### ADDENDUM #3 TO BID #20-020

**PROCUREMENT FOR: Garden City Drainage Improvements Sites 1, 5 and 8**

This addendum will amend **Bid #20-020, Garden City Drainage Improvements Sites 1, 5 and 8** originally issued on Wednesday, April 8, 2020. This clarification is being provided to all known and registered correspondents in response to questions received. All addenda and original bid documents are also available online at: [www.gtcounty.org](http://www.gtcounty.org), select “Bid Opportunities” from the Quick Links section and “View Current Bid Solicitations.”

Revision Sheet 4 of 14	Drawing No. C2-00
---------------------------	----------------------

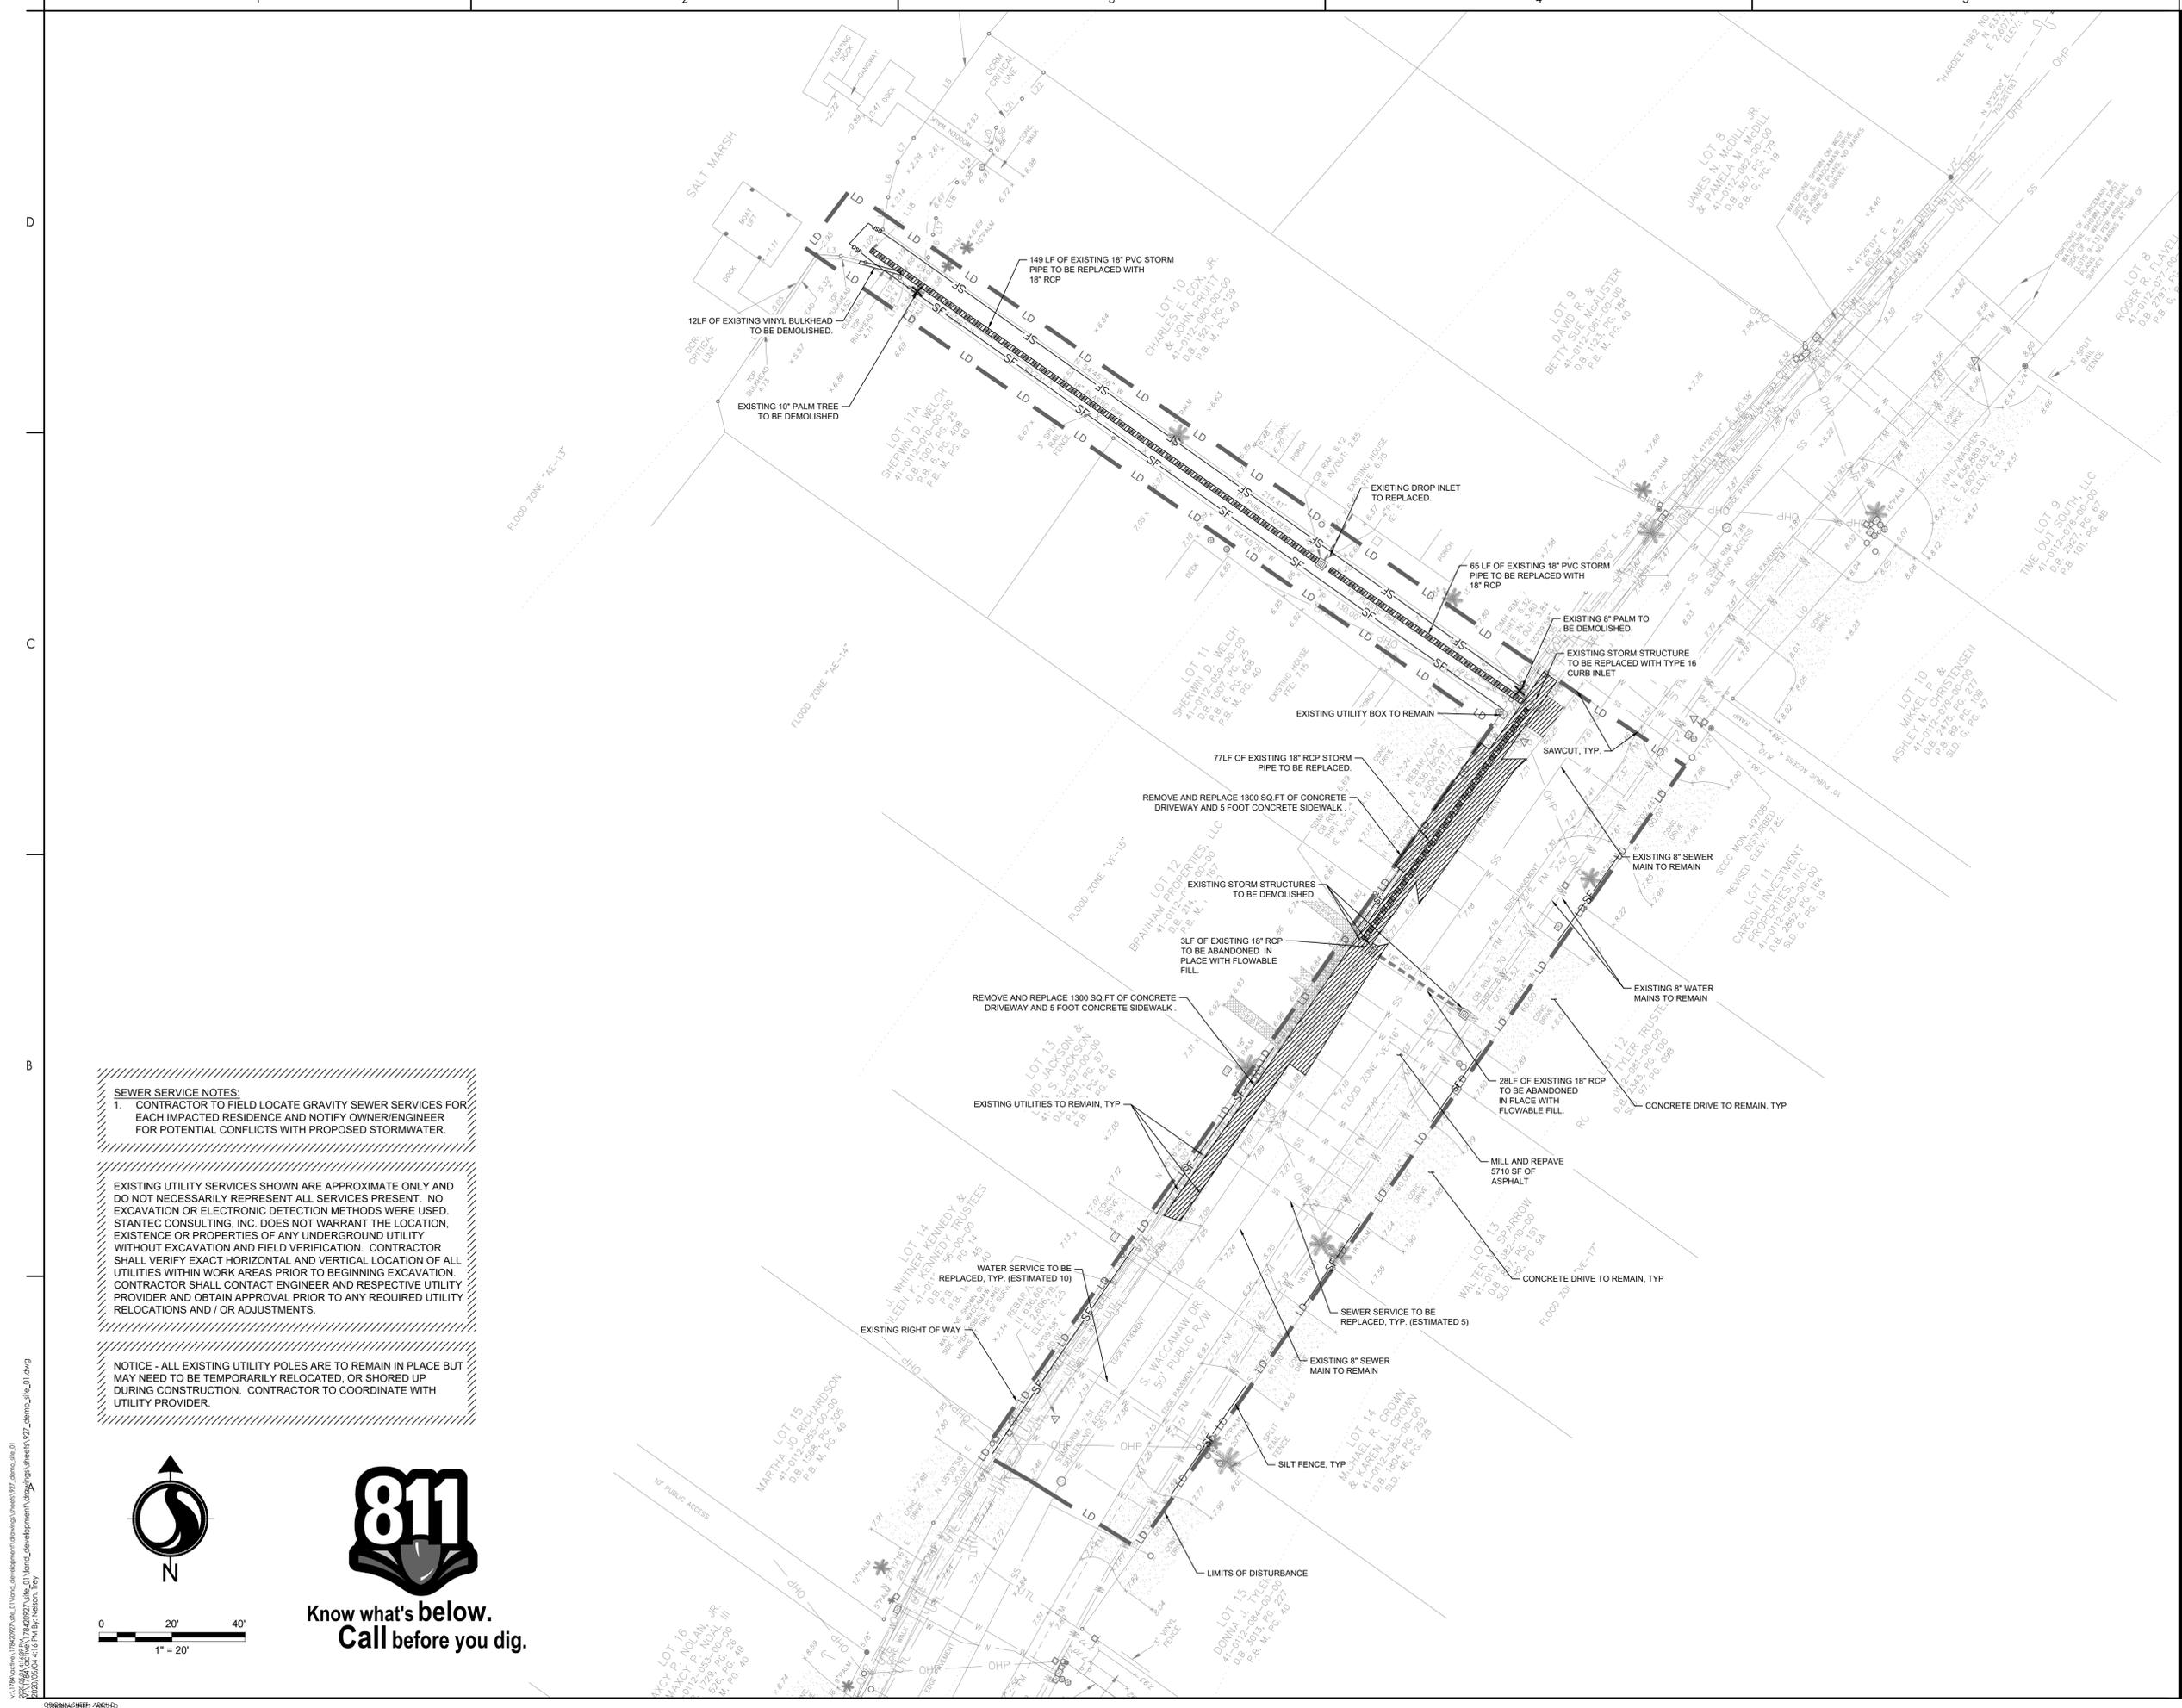
**Question #18: SCOPE OF ASPHALT MILLING/OVERLAY/NEW PAVEMENT:** As a typical example, referring to Site #5, Drwg. C2-00 through C2-02, and Drwg. Nos. C3-00 through C3-02, versus “asphalt paving drawings” C4-00 through C4-02, indicate different scopes as to the extent for new asphalt paving. The C4 drawings, basically, do not include turn outs. The turn outs are obviously more costly than the “straight line paving”. Please clarify the extent of new asphalt pavement. Not only on Site #5, but entire project.

**Response:** Sheet C4-00-C4-02 reflect all required paving.

Revision Sheet	Drawing No.
8 of 14	C4-00

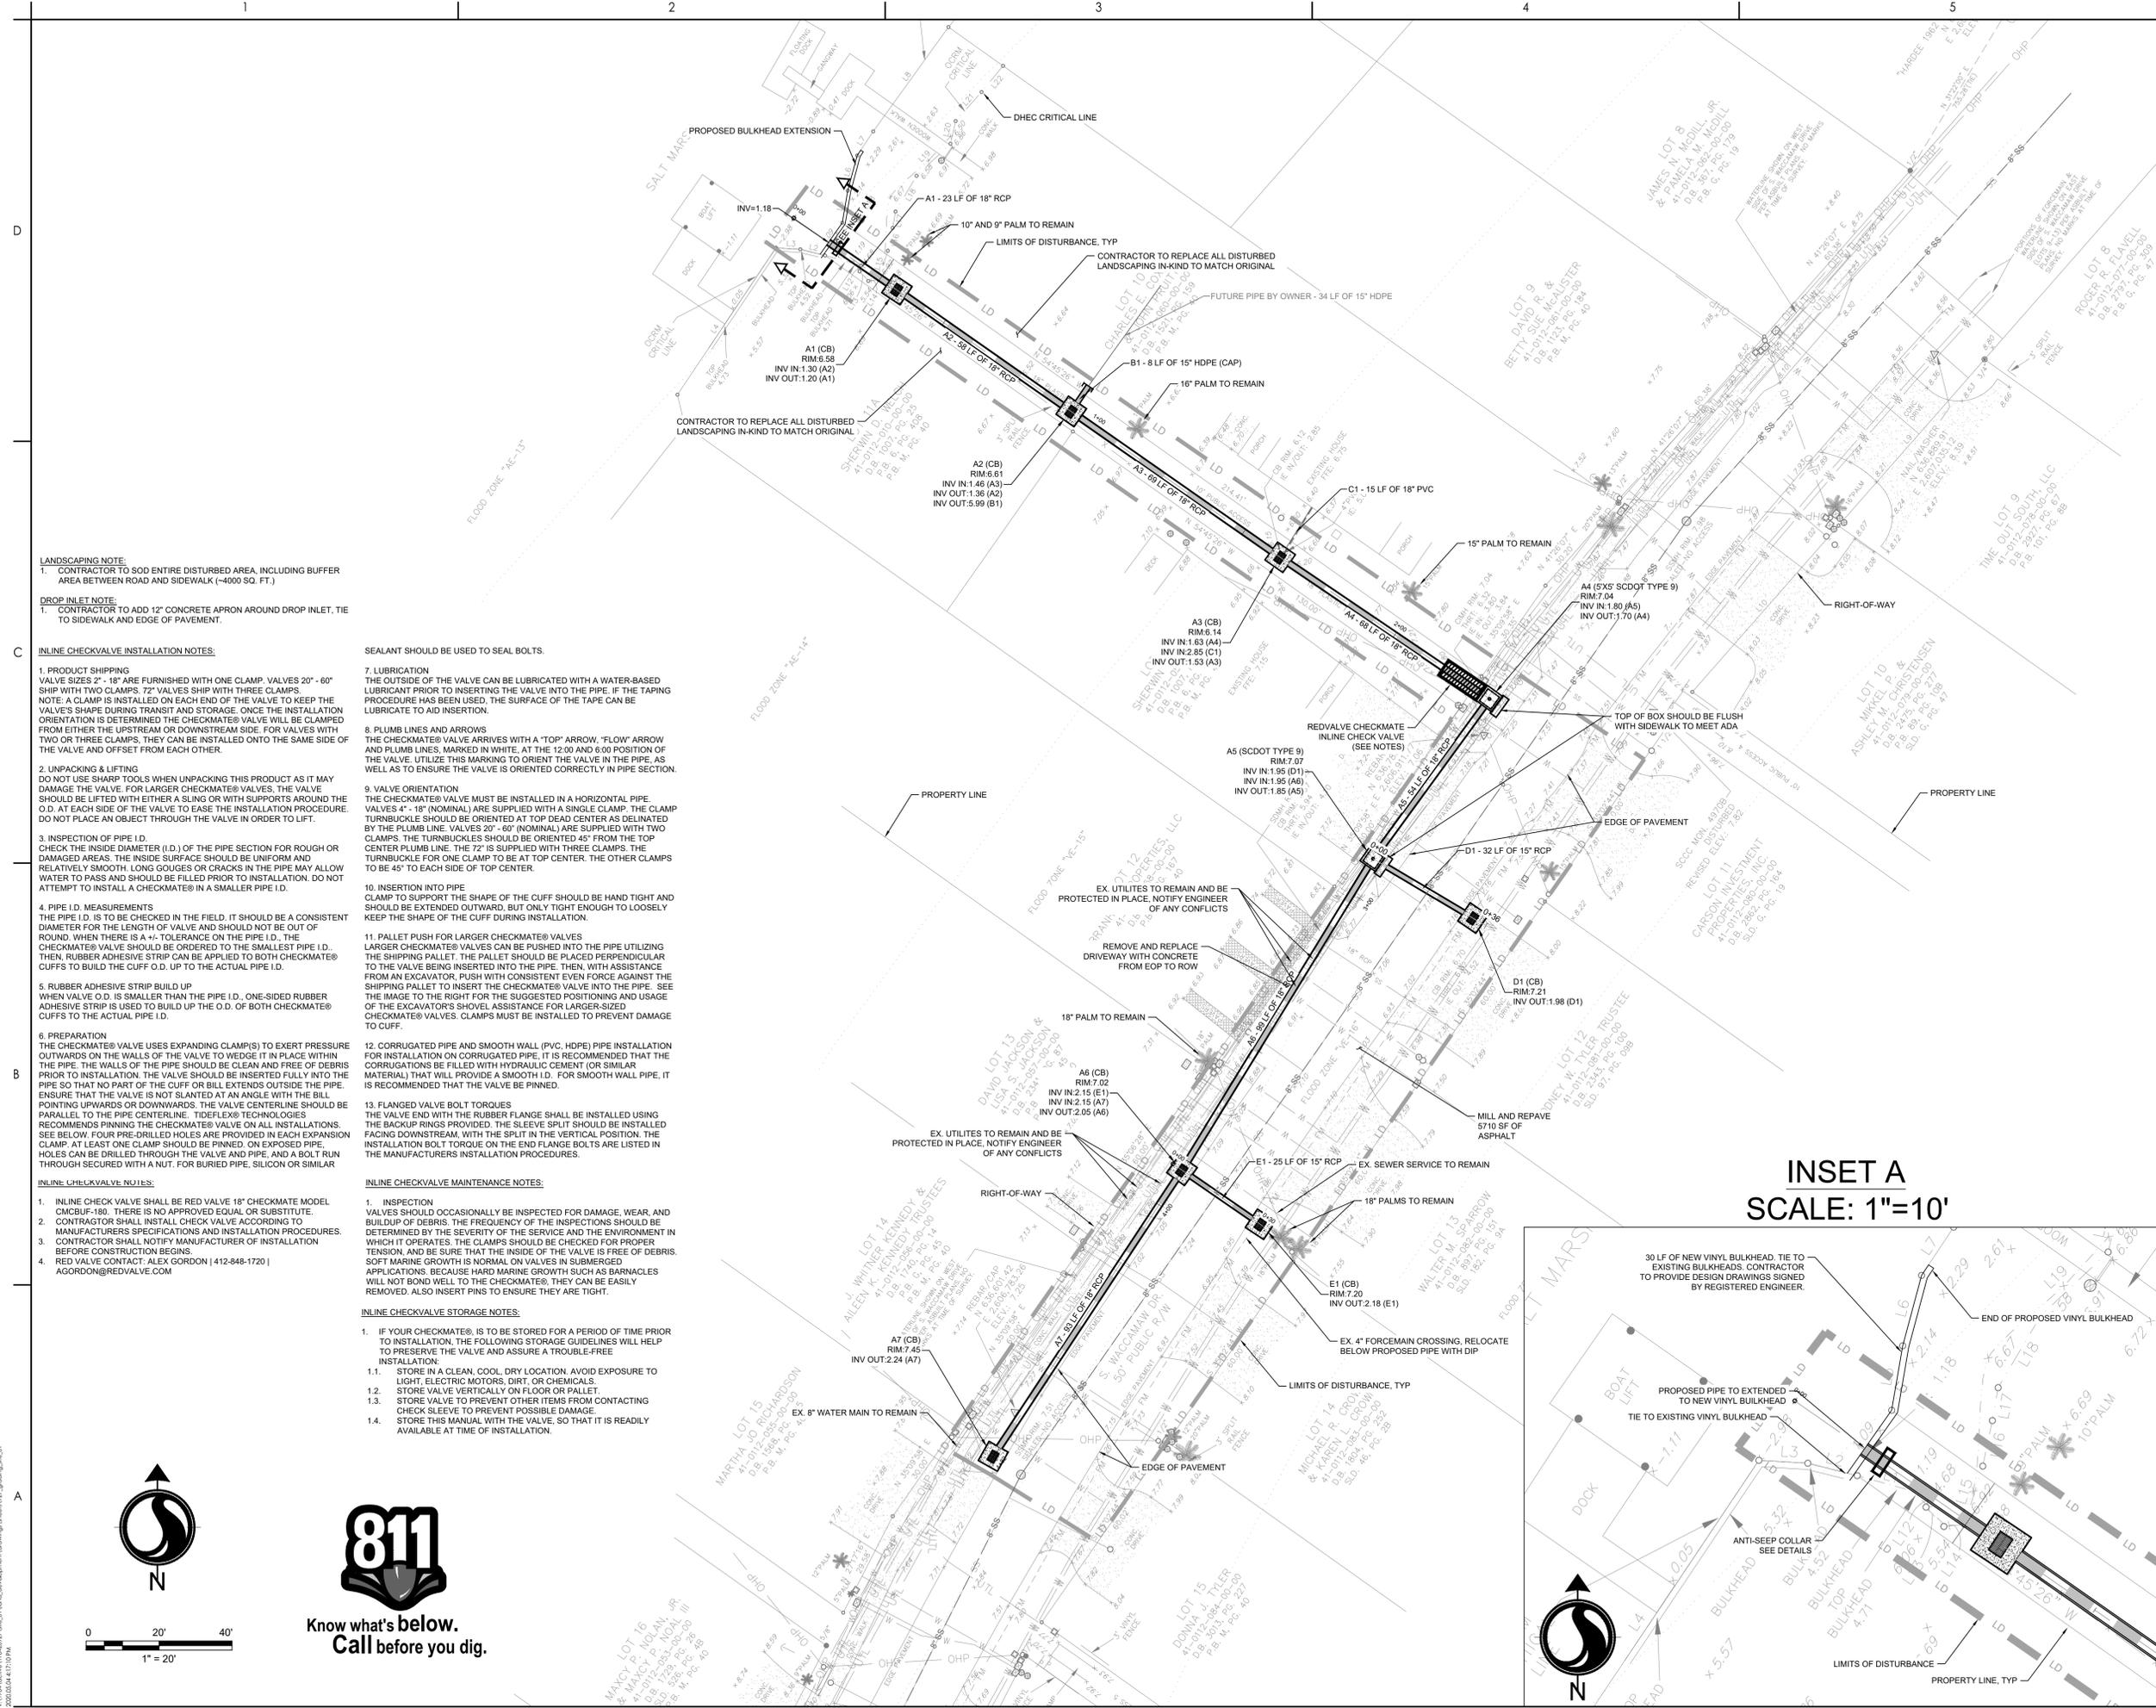
**Question #5: BID ITEM #17 – CURB INLETS (SCDOT TYPE 9):** Drawing C4-00 indicates Type 16. Please clarify.

**Question #6: BID ITEM #13:** Bid Item #13 indicates 8 LF of 15” RCP. Drawing C4-00 and C4-01 indicate 15” HDPE with cap. Please clarify.

**Response:** Bid Item #17 should read “CURB INLETS (SCDOT TYPE 16).”

**Response:** Bid Items #13 should read 8 LF of 15” HDPE.
